## COUNCIL ASSESSMENT REPORT

Panel Reference	2017 WES 009
DA Number	D2017-499
LGA	DUBBO REGIONAL COUNCIL
Proposed Development	OUTDOOR RECREATION FACILITY (SWIMMING POOL)
Street Address	13A NANIWA CRESCENT, WELLINGTON 2820
Applicant/Owner	DUBBO REGIONAL COUNCIL
Date of DA lodgement	5 OCTOBER 2017
Number of Submissions	18
Recommendation	CONDITIONAL APPROVAL
Regional Development Criteria (Schedule 4A of the EP&A Act)	<ul style="list-style-type: none"> <li>COUNCIL DEVELOPMENT APPLICATION.</li> <li>CAPITAL INVESTMENT VALUE OF \$7.5 MILLION.</li> </ul>
List of all relevant s79C(1)(a) matters	<p>i.e. any:</p> <ul style="list-style-type: none"> <li>relevant environmental planning instruments</li> <li>proposed instrument that is or has been the subject of public consultation under the Act and that has been notified to the consent authority</li> <li>relevant development control plan</li> <li>relevant planning agreement that has been entered into under section 93F, or any draft planning agreement that a developer has offered to enter into under section 93F</li> <li>coastal zone management plan</li> <li>relevant regulations e.g. Regs 92, 93, 94, 94A, 288</li> </ul>

**REPORT:** Lot: 701 DP: 1

Figure 5: Originally submitted site plan

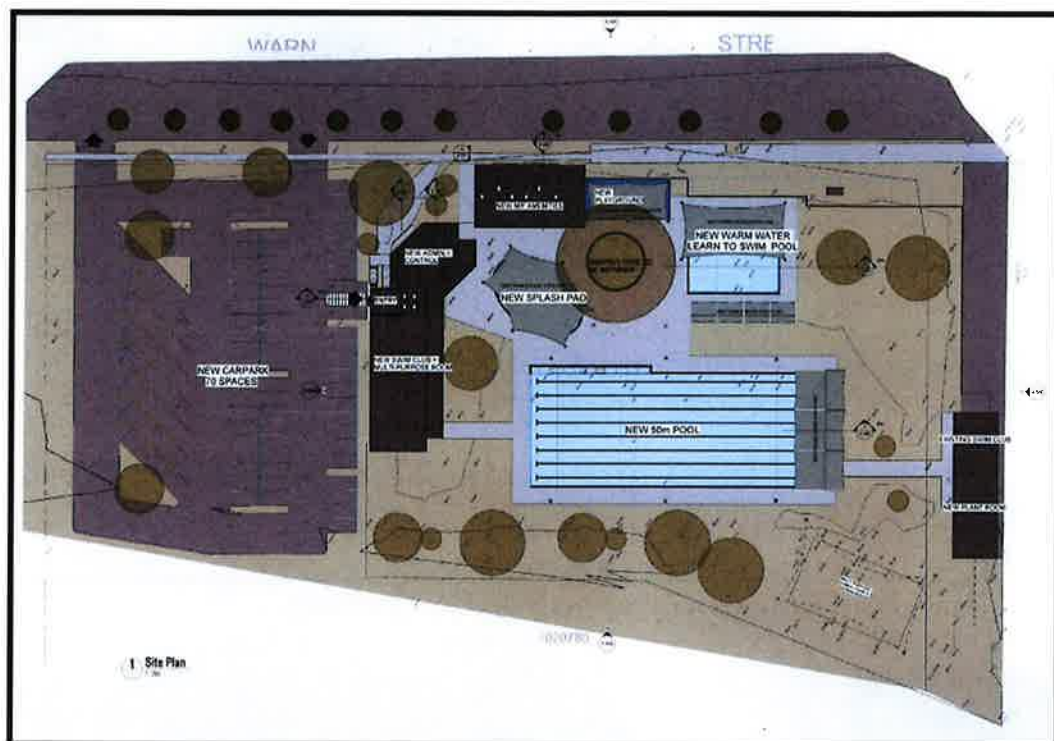
- The original development application proposed the full demolition of the existing Wellington Memorial Pool building and all associated pools and structures (refer to Figure 5 below).

- The plans were referred to Council's Heritage Advisor, and a Heritage Impact Statement (HIS) was requested from the applicant.
- The HIS, prepared by David Scobie Architects dated December 2017, confirmed that the development site was a heritage listed item within a heritage conservation area, and that the 'Wellington Memorial Pool' Pavilion and adjoining Warne Street brick walls had 'exceptional' and 'moderate' heritage values and should be retained.

- The HIS also identified that the additional tree planting should be provided for the originally proposed 71 space car park, and that alternative elevations for the new buildings to address the architecture of the setting should be adopted.

Figure 6: Amended site plan

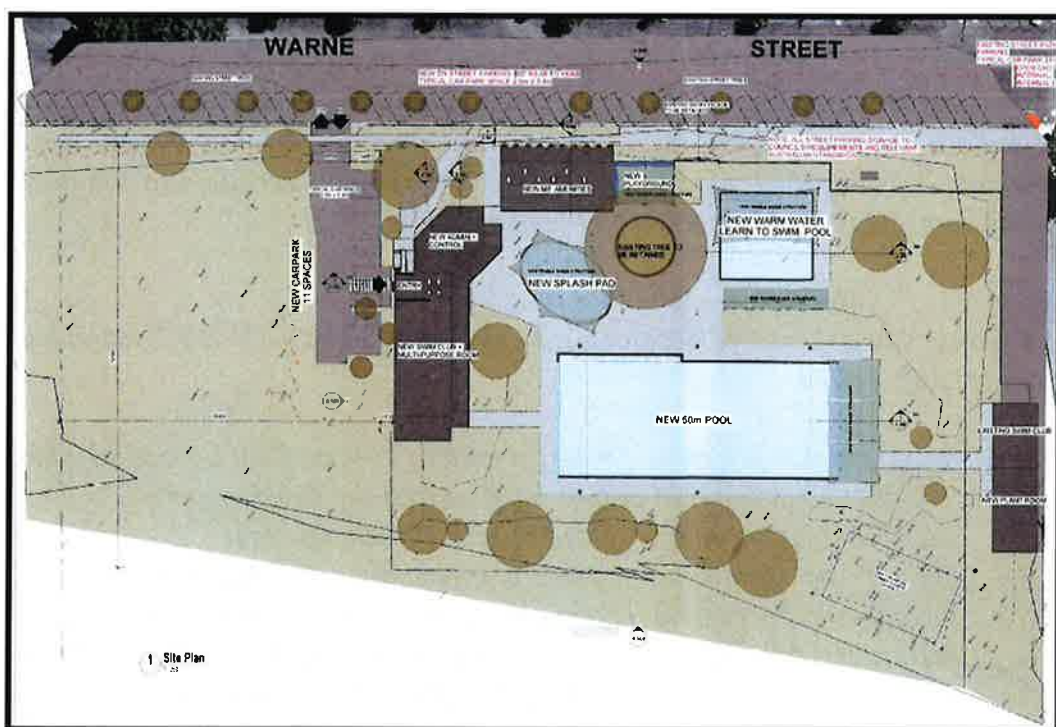
- Initially, amended plans retaining only the central façade of the Wellington Pool Pavilion as a fencing feature with window graphics, and showing a reduced 11 space car park, was re-submitted to Council for assessment (Refer to figure 6 below).

- The amended plans were re-referred to Council's Heritage Advisor for comment.

- Council's Heritage Advisor considered the amended plans to be insufficient in relation to the recommendations of the HIS and requested substantial amendments to protect the existing entrance pavilion and Warne Street walls as required by the HIS and further consideration of the existing pools heritage values.
- In response, further plans were submitted which show that the full entrance pavilion and adjoining façade walls will be retained and joined to the proposed buildings, and that the amended 11 space car park will be retained. The existing pools will continue to be replaced (refer to Figure 7 below).
- Council's Heritage Advisor, in his revised memo dated 18 January 2018 has made the following comments in relation to the final plans, and recommended them for approval:
